## NINE MILE POINT NUCLEAR STATION

**SUBJECT:** Nine Mile Point Nuclear Station  
Unit No. 2; Docket No. 50-410

Response to Request for Additional Information Regarding Nine Mile Point Nuclear Station, Unit No. 2 – Re: The License Amendment Request for Extended Power Uprate Operation (TAC No. ME1476) – Anticipated Transient Without Scram Simulator Tests and Net Positive Suction Head for Emergency Core Cooling Systems

**RESPONSE TO REQUEST FOR ADDITIONAL INFORMATION  
REGARDING LICENSE AMENDMENT REQUEST FOR EXTENDED  
POWER UPRATE OPERATION**

Figure 1  
Transient Test EPU Isolated ATWS MELLLA  
RPV Dome Pressure (rrpdome)

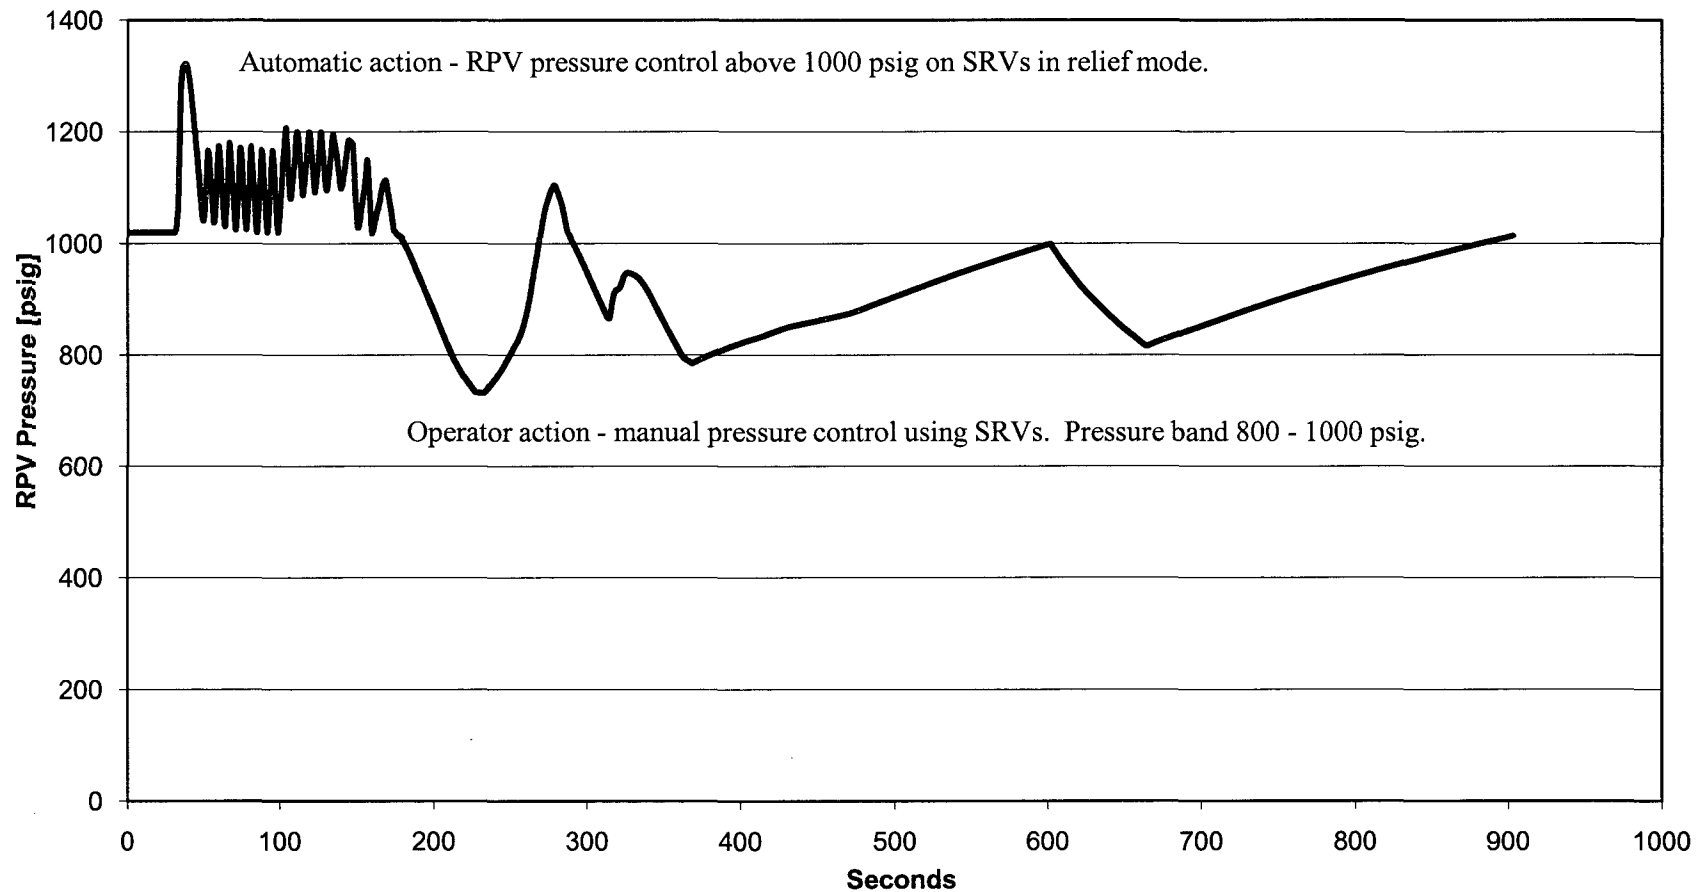
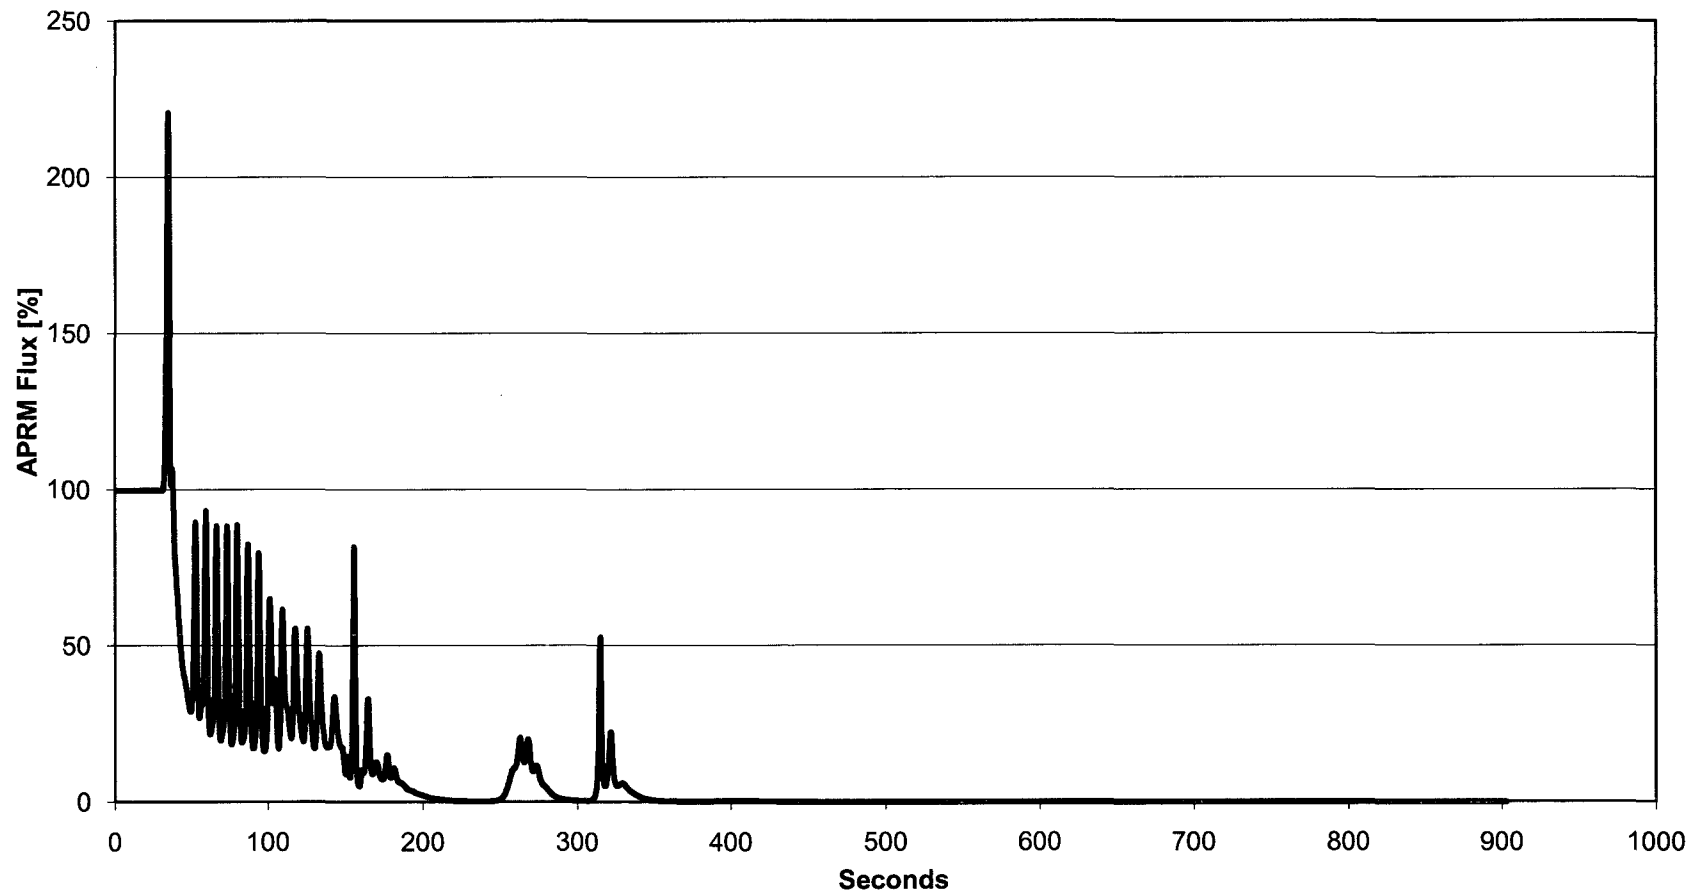
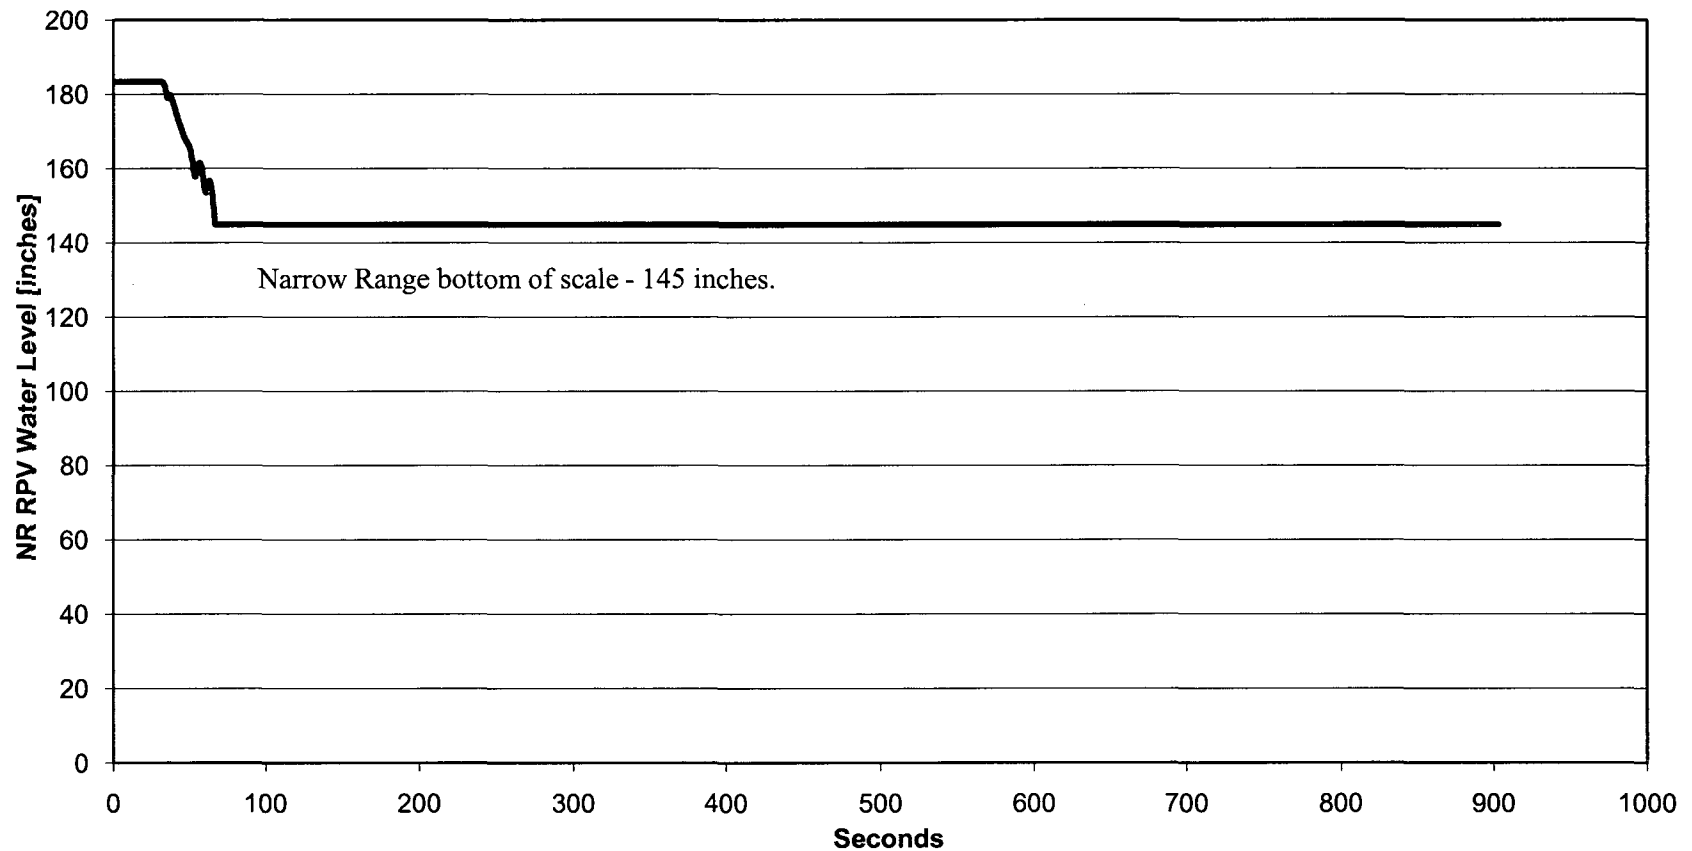
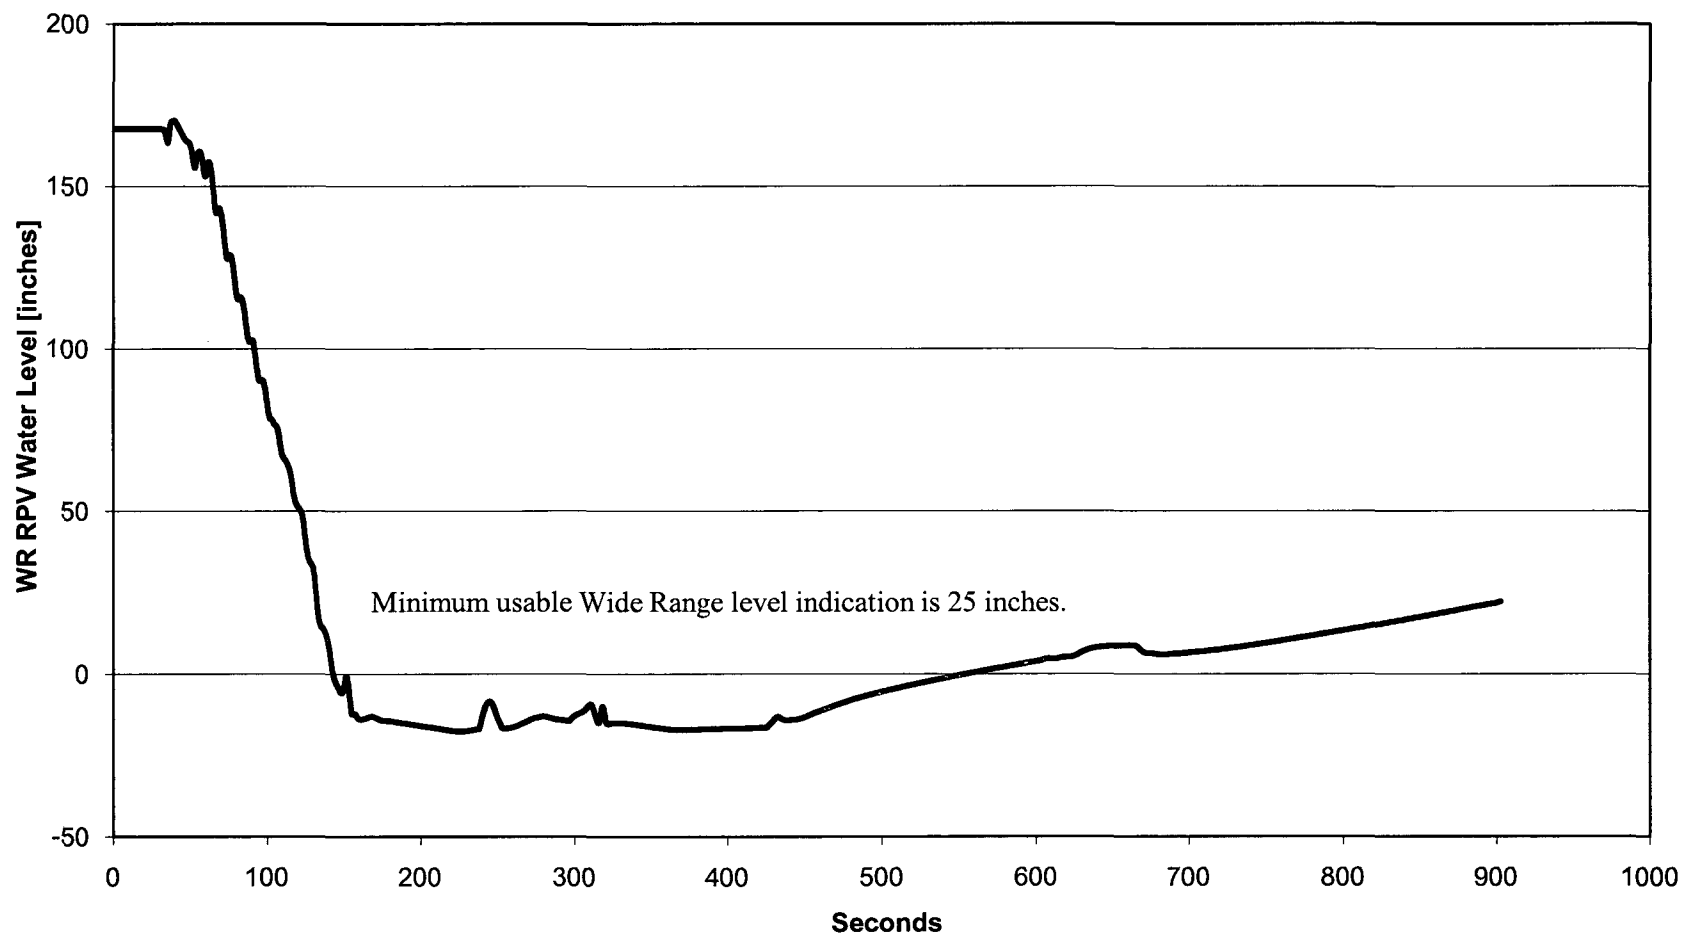
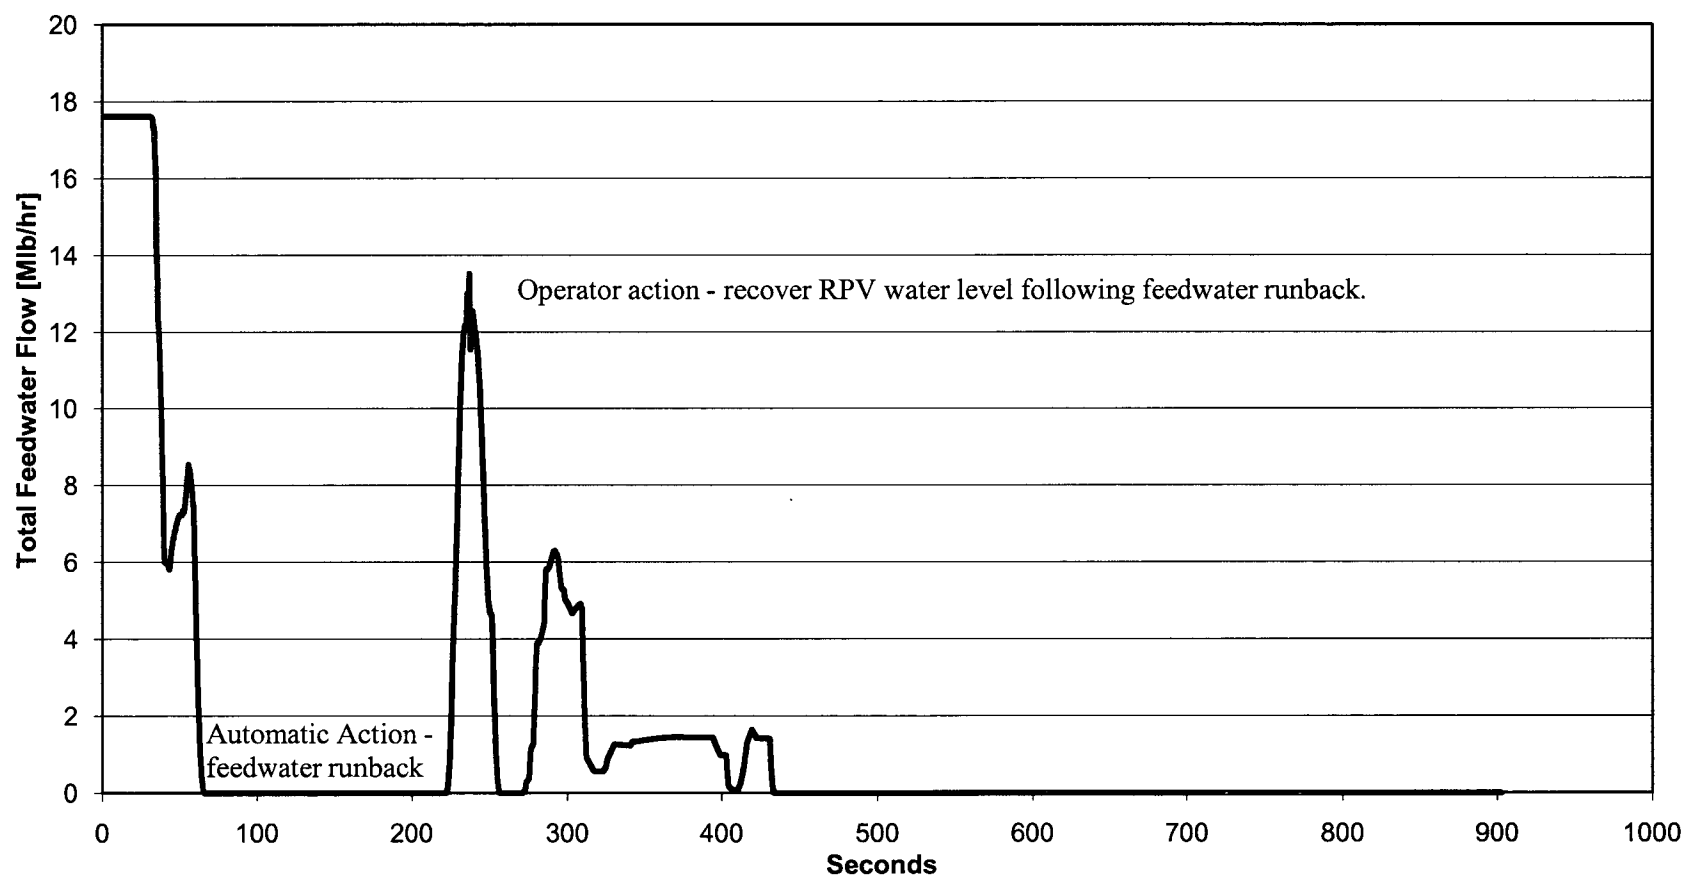
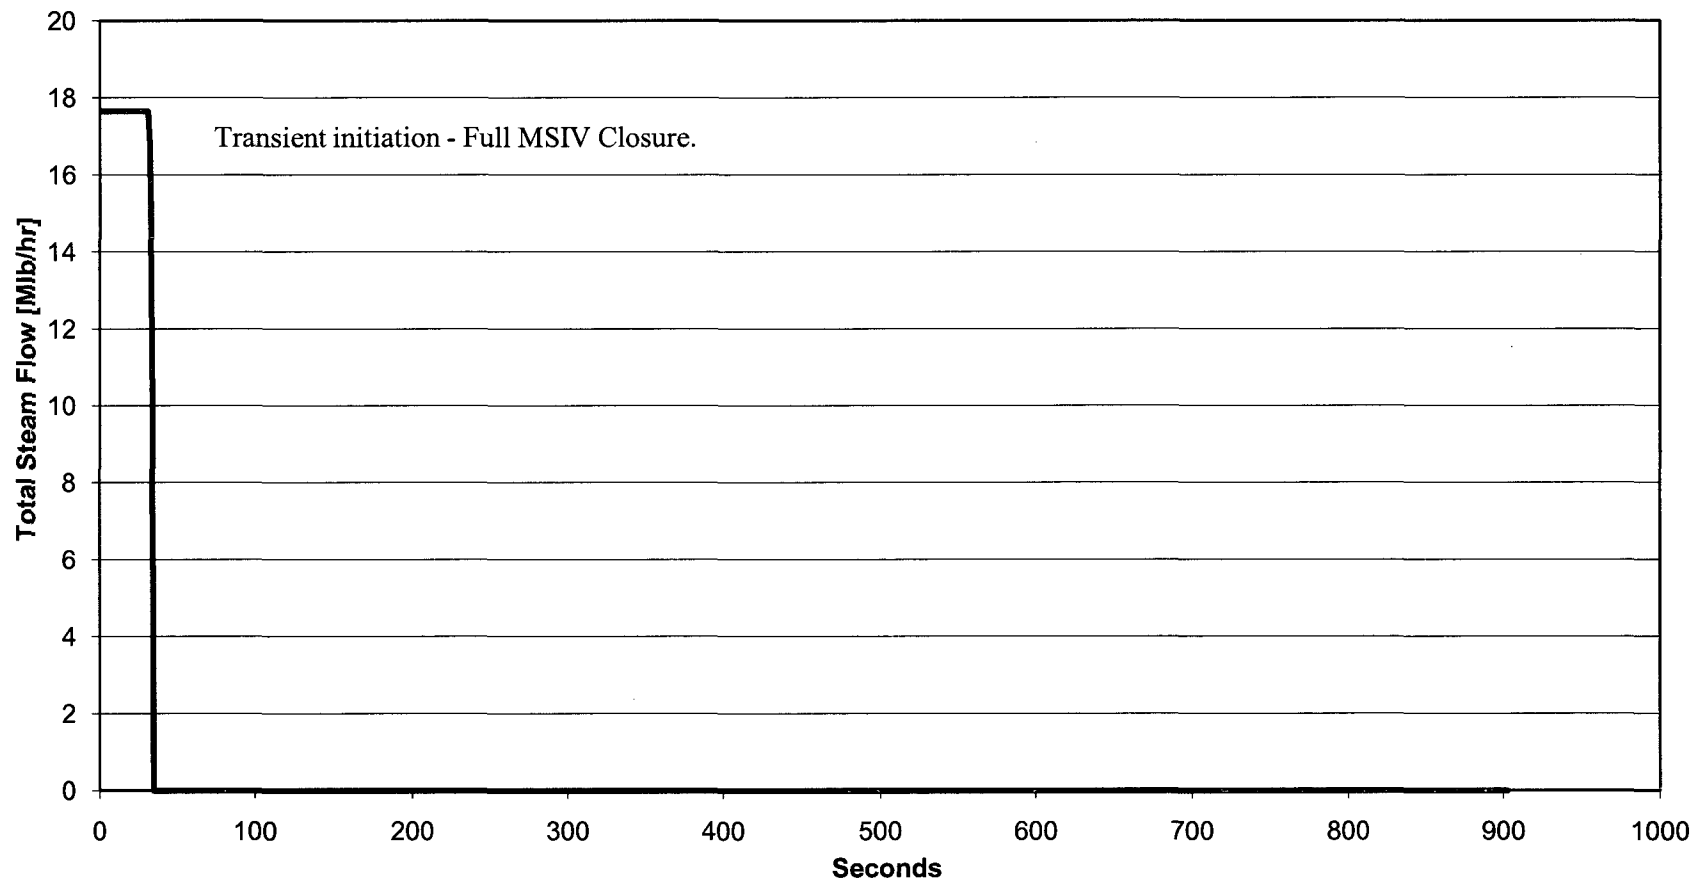
- 1) Provide the sequence of both events with the transient response(s) corresponding to ATWS emergency operating procedure actions (e.g., turbine trips, recirculation pump trips, turbine bypass valves open, power increases, water level reduction, standby liquid control system injection, to steady state/oscillation under control, etc.)*
- 2) For clarity of the data tables for both the MSIV closure and turbine trip ATWS EPU events, provide the full name/nomenclature with description or definition of each column field (e.g., rrp dome, nmapmfx\_z, fws1a101, etc.).*
- 3) In addition to the [Reactor Pressure Vessel] RPV Pressure vs. Time plots in both events, please include an overlay plot of Power versus Time (i.e., show power oscillations/response corresponding to the RPV pressure response).*

T = 0            All MSIVs close. Closure time is four seconds  
T = 3.6        High reactor pressure initiates RRCS. Reactor Recirculation pumps transfer to slow speed  
T = 5.1        Peak neutron flux of 225%  
T = 8.6        Peak Reactor Pressure Vessel (RPV) pressure of 1350 psig  
T = 28.6       Automatic action – Reactor Recirculation pumps trip to OFF, feedwater runback terminates feedwater injection  
T = 60.6       Suppression Pool temperature reaches Boron Injection Initiation Temperature (BIIT) of 110°F  
T = 113        Automatic action – Boron injection initiated  
T = 116        Operator action – injection sources other than Reactor Core Isolation Cooling (RCIC), Control Rod Drive (CRD) and boron are terminated and prevented  
T = 151        Operator action – pressure band of 800 – 1000 psig established using Safety Relief Valves (SRVs)  
T = 199        Operator action – commence RPV level recovery following feedwater runback. Directed level band is from Minimum Steam Cooling Water Level (MSCWL) to Top of Active Fuel (TAF)

T = 251        Average Power Range Monitor (APRM) neutron flux is downscale, less than 4%  
T = 273        Operator action – First loop of Residual Heat Removal (RHR) is in Suppression Pool cooling at rated flow of 7450 gpm  
T = 275        Operator action – RPV water level restored and maintained within directed band  
T = 339        Suppression Pool temperature reaches maximum value of 134.9°F  
T = 404        Operator action – second loop of RHR is in Suppression Pool cooling at rated flow of 7450 gpm  
T = 406        Reactor is in hot shutdown as indicated by neutron flux <0.1% on APRMs

Figures 1 through 27 depict the plant response for a number of parameters.
